**APPLICATION FOR  
URBAN DESIGN COMMISSION  
REVIEW AND APPROVAL**

**AGENDA ITEM #** 6  
**Project #** 3-23-06  
03106

June 7, 2006

**SUBJECT: 1121-1155 Erin Street and 707-719 South Orchard Street**

DATE  
 03/22/06  
 SHEET TITLE  
 Site Plan

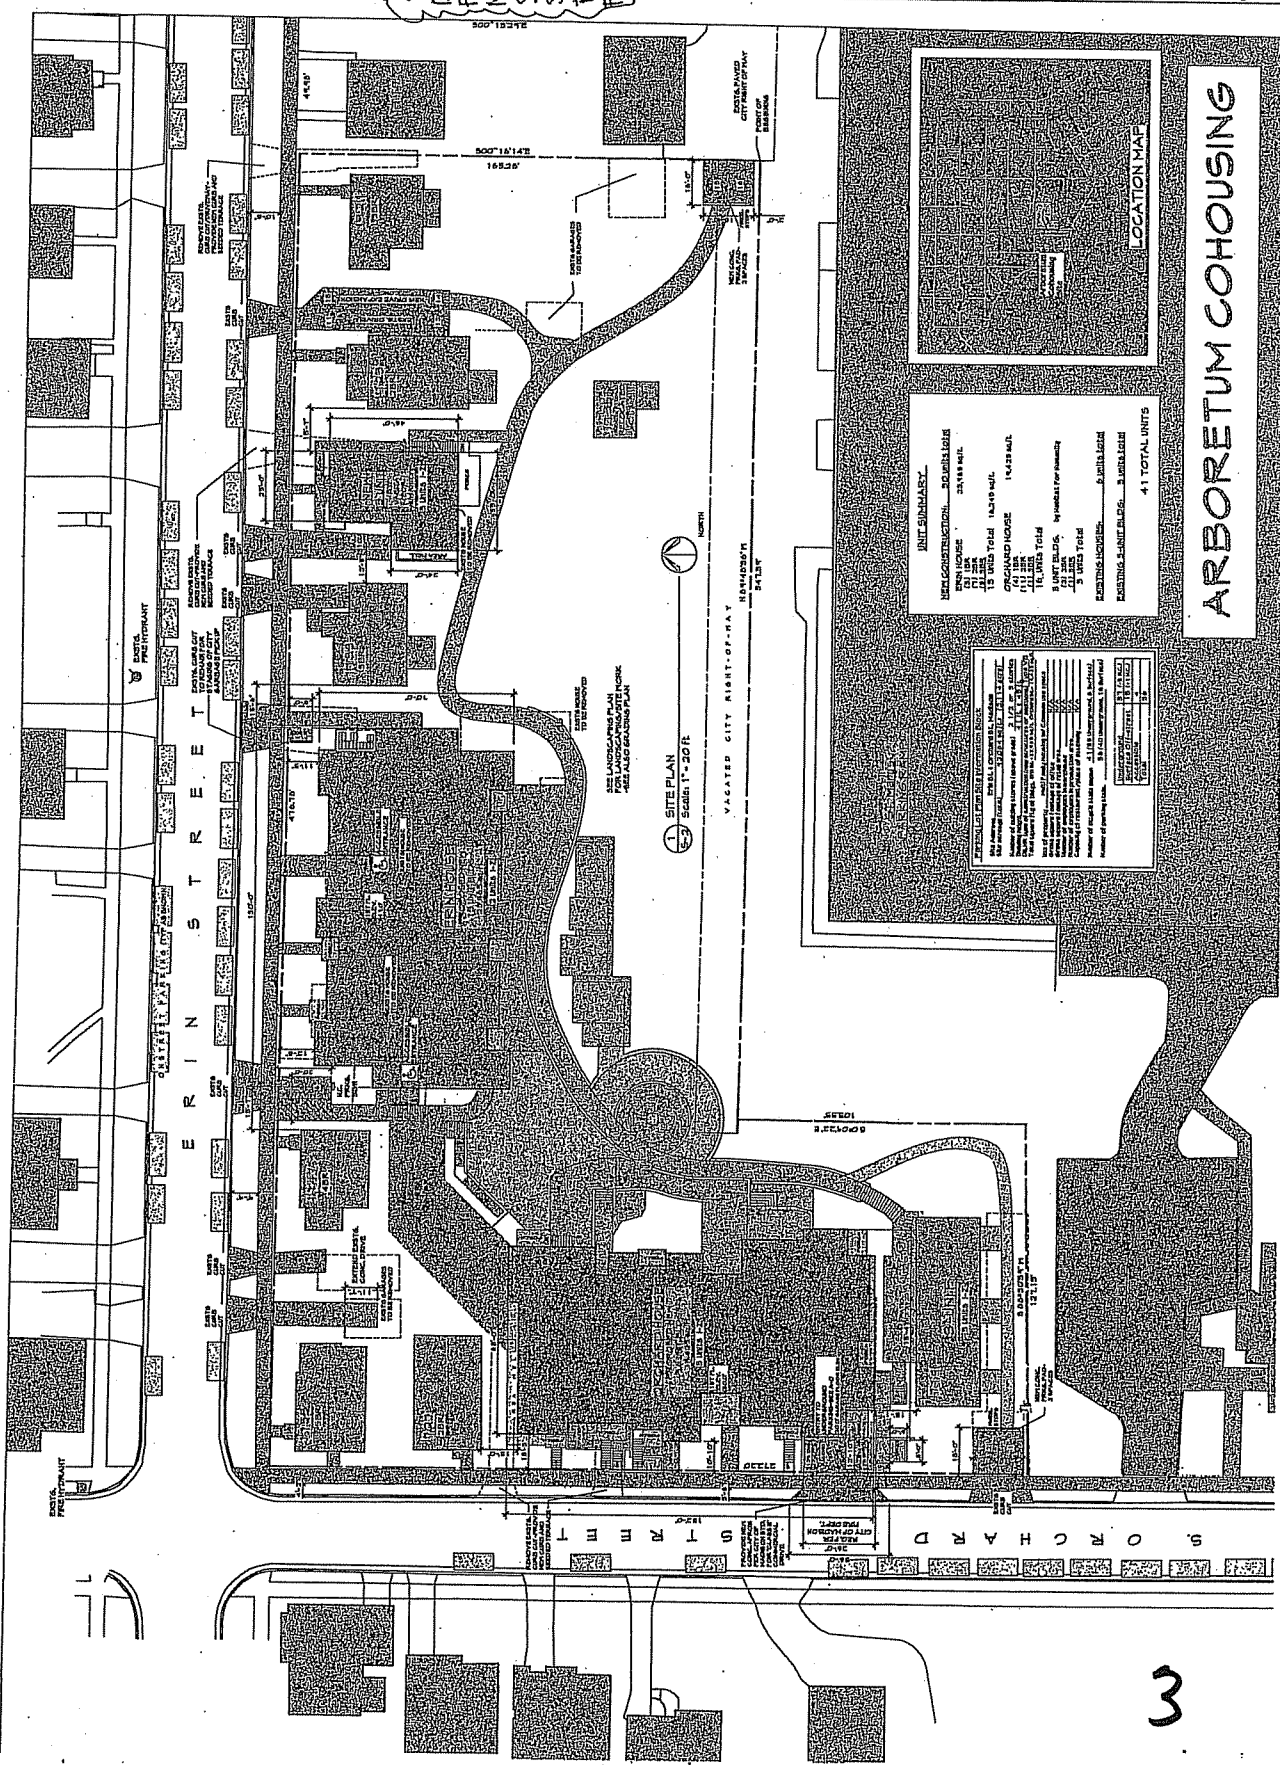
SHOWS ORIGINAL  
 BUILDING  
 FOOTPRINTS OF  
 NEW BUILDINGS-  
 SEE REVISED  
 SHEET  
 FOR NEW  
 FOOTPRINTS
